# TECH BULLETIN

**005**  
08/77

## SUBJECT: “B” Manifold and Stepped Valve Seat

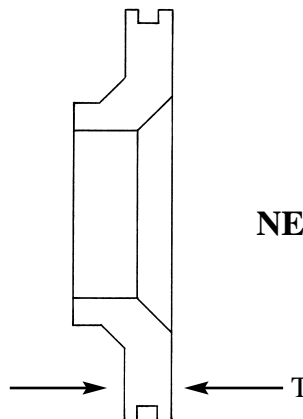
Beginning with May 1977, a back-up ring was added to the Valve Seat on all 10 Frame pumps. A thicker “stepped” Valve Seat was necessary to hold the added back-up ring and o-ring. A new manifold marked with a “B” with a deeper valve chamber was also necessary for this change.

It is important that parts are not interchanged from one design to another. However, with the use of PN 30452 spacer, the old Valve Seat with o-ring only may be used in the new style manifold-B.

### OLD Valve Seat

T = .157" (4.0 mm)  
PN 27350

### NEW Stepped Valve Seat

T = .197" (5.0 mm)  
PN 43046
